### **3 DESIGN OF STRUCTURES, COMPONENTS, EQUIPMENT AND SYSTEMS**

This chapter of the U.S. Nuclear Regulatory Commission's (NRC's) safety evaluation report (SER) provides the NRC staff evaluation of the North Anna 3 design of structures, components, equipment and systems.

**Figure 3.7.4-1. Plot comparing the CSDRS derived OBE (a) and the site-specific OBE (b) with the other requirements used to determine an OBE exceedance.**

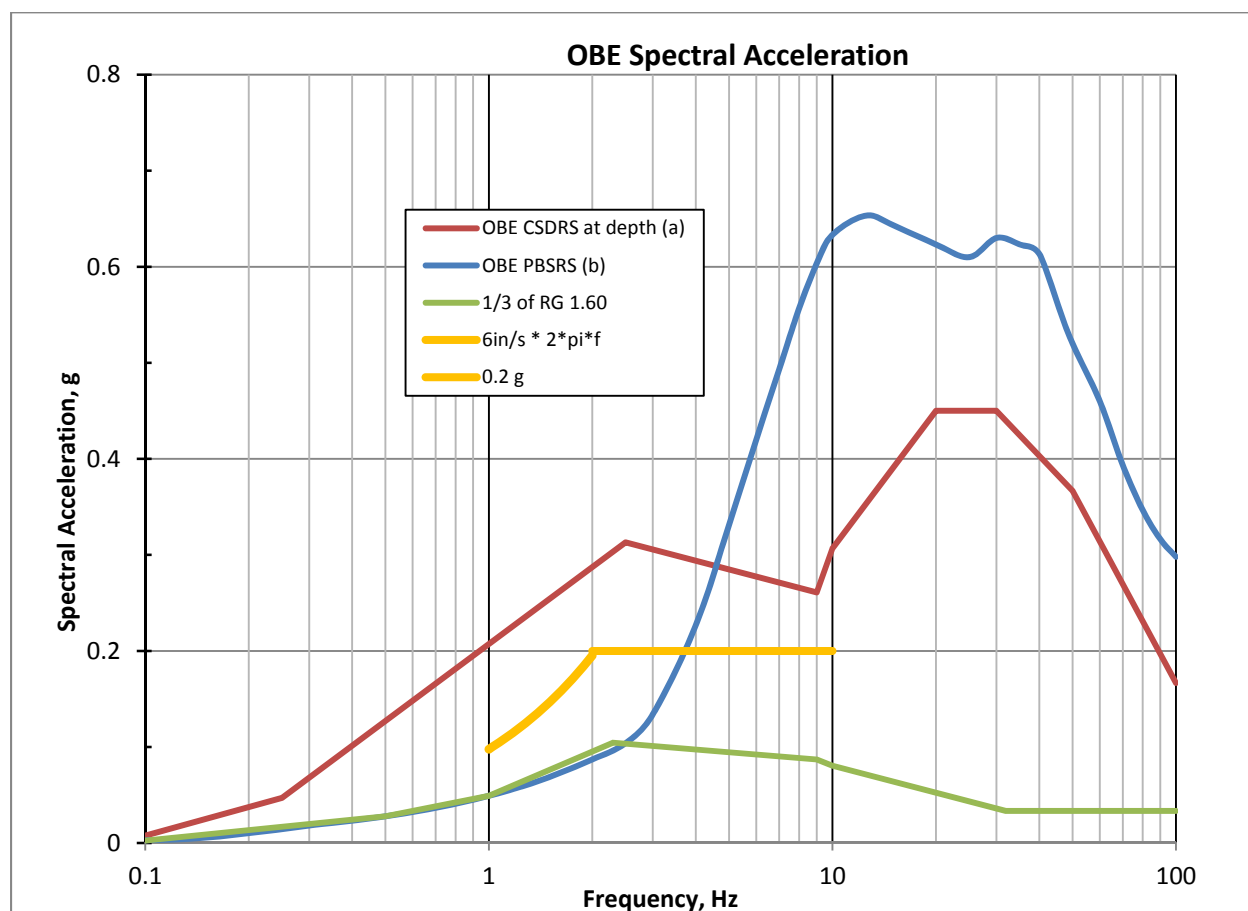
motion. The staff requested that the applicant specify how this definition of OBE exceedance meets the requirements of Appendix S to 10 CFR Part 50, and is consistent with the guidance in DC/COL-ISG-1.

In its response, the applicant stated that all safety-related SSCs are designed, analyzed, and qualified to meet both the ESBWR CSDRS and the site-specific FIRS (Figure 3.7.4-1). The applicant also clarified that an OBE exceedance is declared when a recorded ground motion exceeds both the (a) CSDRS-derived and (b) site-specific OBE, but that these exceedances need not occur at the same frequency (i.e., envelope of (a) and (b) are not considered). For example, an earthquake response spectrum that falls below the envelope of (a) and (b), but exceeds (b) at low frequency and (a) at high frequency, would be considered an OBE exceedance, requiring plant shutdown if other criteria, as discussed in FSAR Section 3.7.4.4, are also met. Finally, the applicant stated that the consideration of (a) for determining the OBE at grade is conservative, because this selection neglects the effects of ground motion amplification or site response between the elevation of the RB/FB and CB foundations and plant grade.
